SpeakNoEvil4_micSD_v2.PrjPcb	Hes-SO // VALAIS WALLIS
SpeakNoEvil4_Burn_proto_v2.SchDoc	Date : 2025-10-31
Revision : 1.0	Sheet 1 of 2
	Design by : ANX

SpeakNoEvil4_micSD_v2.PrbPcb		Hes-SO // VALAIS WALLIS	
SpeakNoEvil4_micSD_v2.SchDoc		Date : 2025-10-31	π
Revision : 1.0	Sheet 2 of 2	Design by : ANX	
Q:\ECS\MonkeyBusiness\PCB\TM-AdrienRey\SpeakNoEvil4_micSD_v2\SpeakNoEvil4_micSD_v2.SchDoc

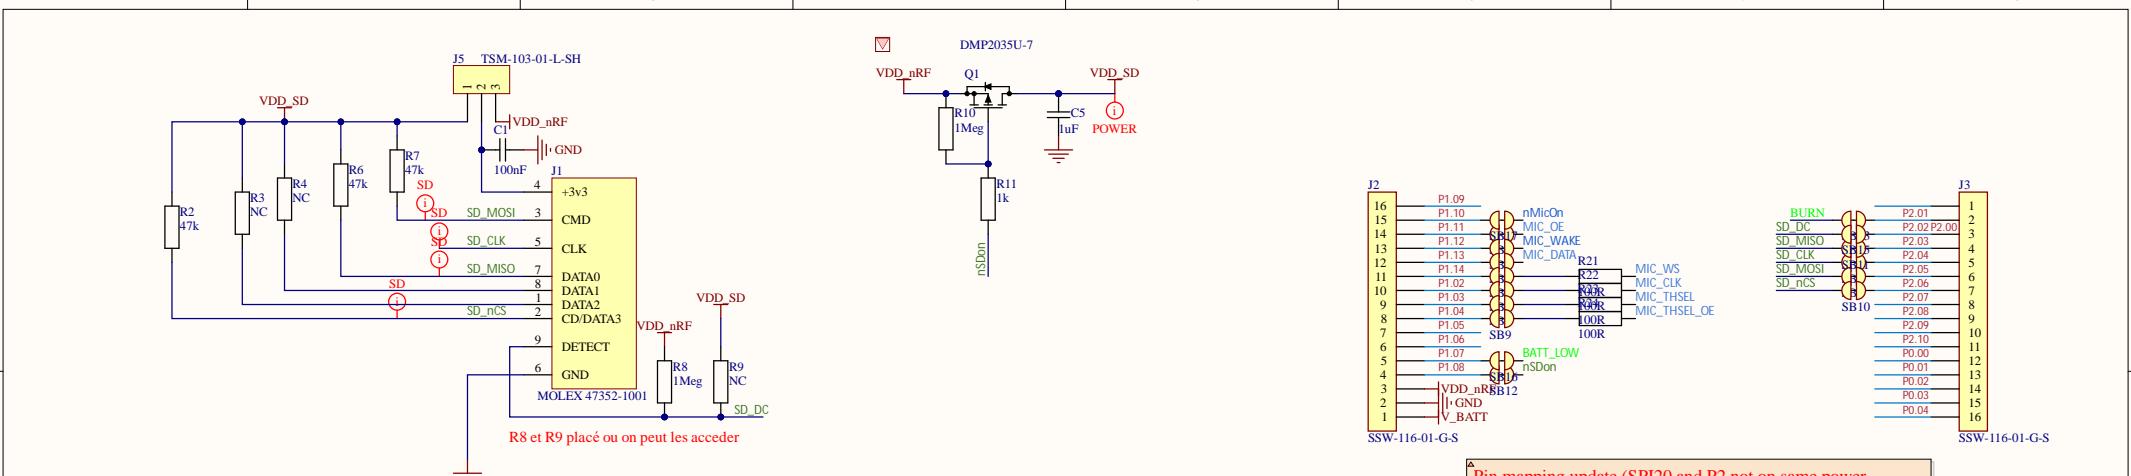
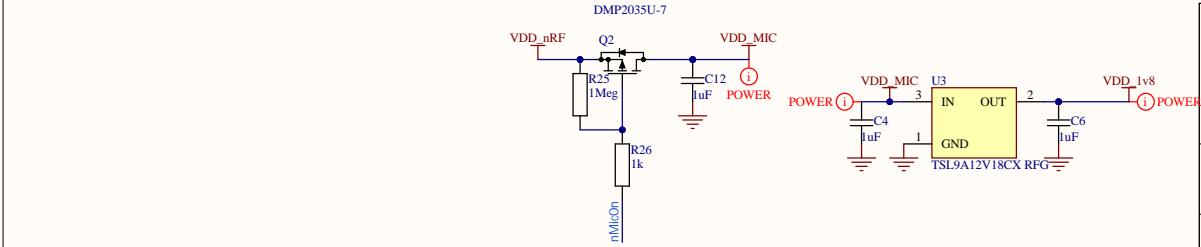
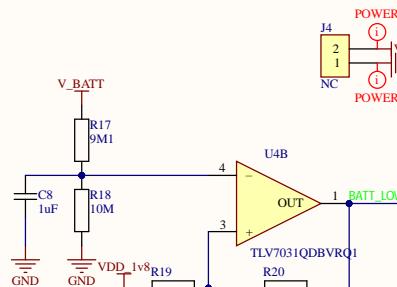
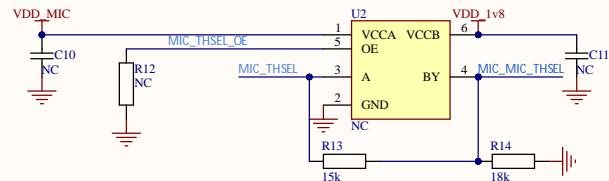
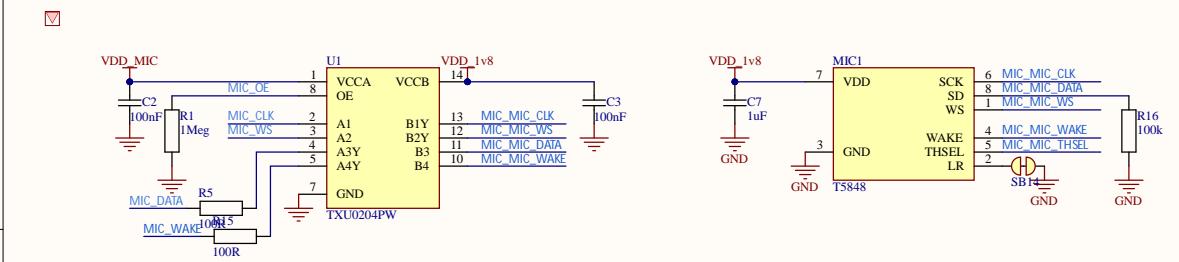
Pin mapping update (SPI20 and P2 not on same power block):
SD_MOSI: P2.05 -> P1.09
SD_CLK: P2.04 -> P1.03
SD_MISO: P2.03 -> P1.04
SD_DC: P2.02 -> P1.05
SD_nCS: P2.06 -> P1.06
MIC_THSEL: P1.03 -> P2.00
MIC_THSEL_OE: P1.04 -> P2.02
